County of San Diego
Planning & Development Services
BUILDING DIVISION

ACCESSIBILITY CORRECTION LIST

Public Accommodations
& Commercial Buildings

**Parking and
Passenger Drop-Off and Loading Zones**

FIGURE 11B-502.2
VEHICLE PARKING SPACES

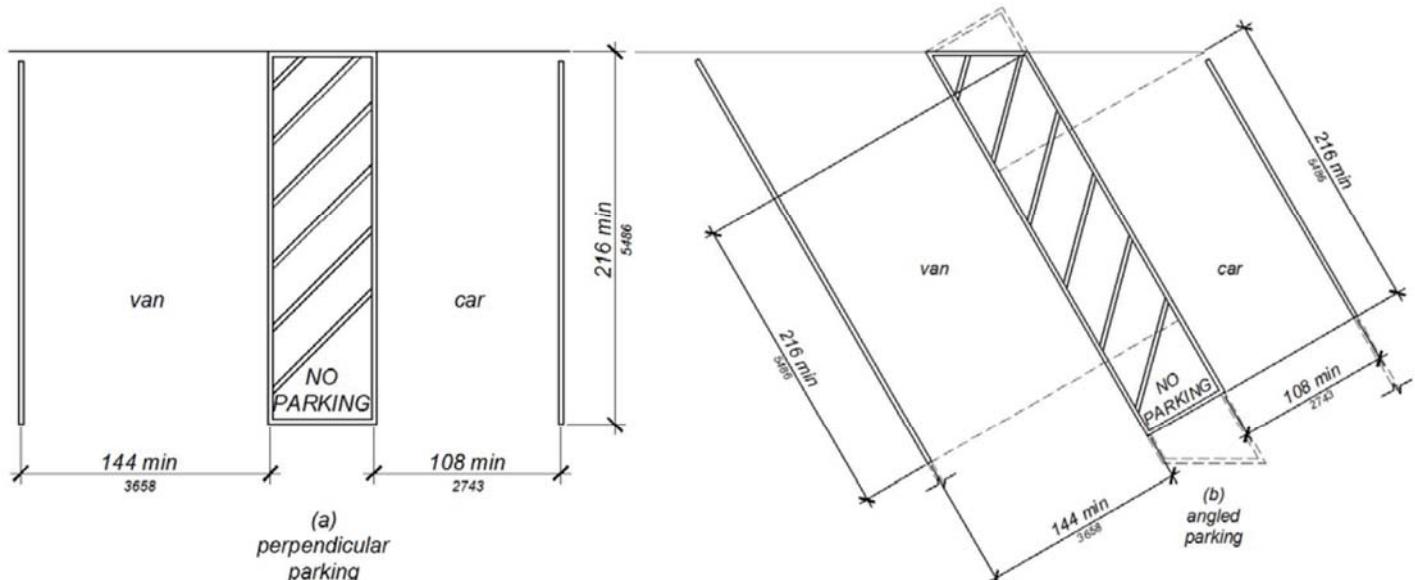
11. Dimension the following at each accessible parking space per CBC Figure 11B-502.2 and CBC Figure 11B-502.3:

- Accessible standard parking spaces:
 - o Minimum 108-inch-wide by minimum 216-inch-long parking stall
 - o Minimum 60-inch-wide access aisle located on either side of parking stall and extending full required length of parking stall
 - Accessible van parking spaces:
 - o Minimum 144-inch-wide by minimum 216-inch-long parking stall
 - o Minimum 60-inch-wide access aisle located on passenger side of parking stall and extending full required length of parking stall
- Exception:** Minimum 108-inch-wide parking stall acceptable with minimum 96-inch-wide access aisle

FIGURE 11B-705.1
SIZE AND SPACING OF TRUNCATED DOMES

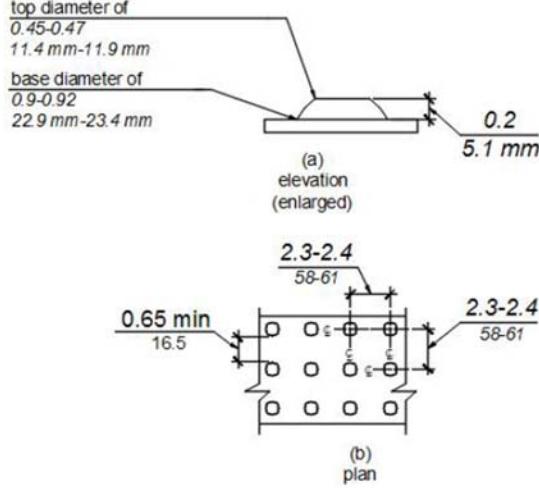
16. At pedestrian ways entering or adjoining parking stalls or access aisles without curb, railing, or barrier separation, detail continuous detectable warning strip complying with the following:

- 36-inches (absolute) deep for entire length/width of transition
- Including raised, truncated domes per CBC Figure 11B-705.1:
 - o Minimum 0.9-inch and maximum 0.92-inch base diameter
 - o Minimum 0.45-inch and maximum 0.47-inch top diameter
 - o 0.20-inch height
 - o Minimum 2.3-inch and maximum 2.4-inch center-to-center spacing and minimum 0.65-inch base-to-base spacing**Exception:** Minimum 1.6-inch and maximum 2.4-inch center-to-center spacing acceptable for domes in radial pattern
- Yellow color – integral to surface – conforming to FS33538 of Federal Standard 595C

**FIGURE 11B-502.3.3
ANGLED AND PERPENDICULAR PARKING IDENTIFICATION**

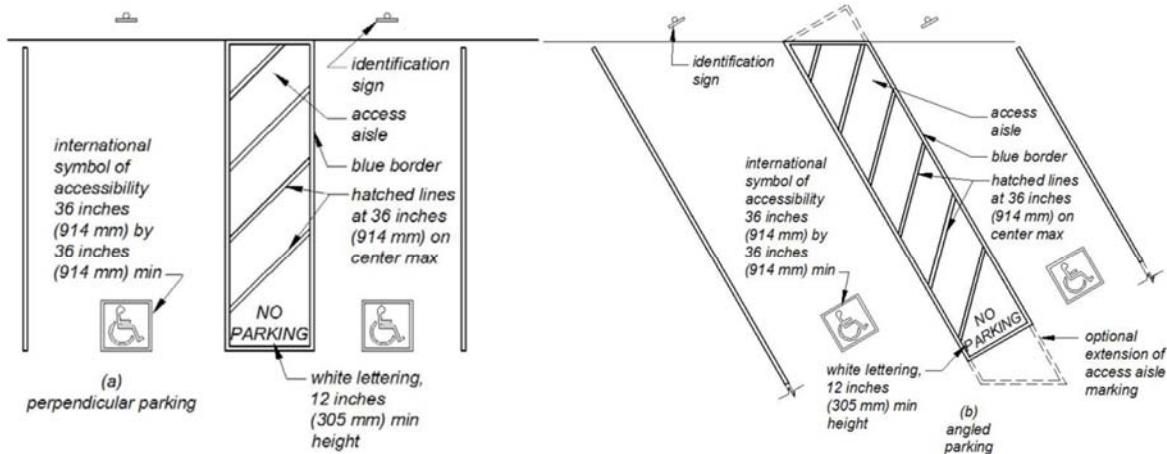
18. Detail surface identification complying with the following at each accessible parking access aisle per CBC Figure 11B-502.3.3:

- Blue access aisle border
- Blue or white hatched lines maximum 36 inches on center within access aisle
- "NO PARKING" painted on ground within access aisle in white letters minimum 12-inches high and located for visibility from the adjacent vehicular way

**FIGURE 11B-503.3
PASSENGER DROP-OFF AND LOADING ZONE ACCESS AISLE**

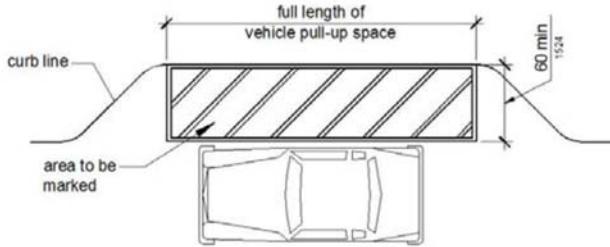
29. Dimension the following at each passenger drop-off and loading zone per CBC Figure 11B-503.3:

- Minimum 96-inch-wide vehicle pull-up space
- Minimum 60-inch-wide access aisle adjacent and parallel to vehicle pull-up space
- Minimum 20-foot-long vehicle pull-up space and access aisle
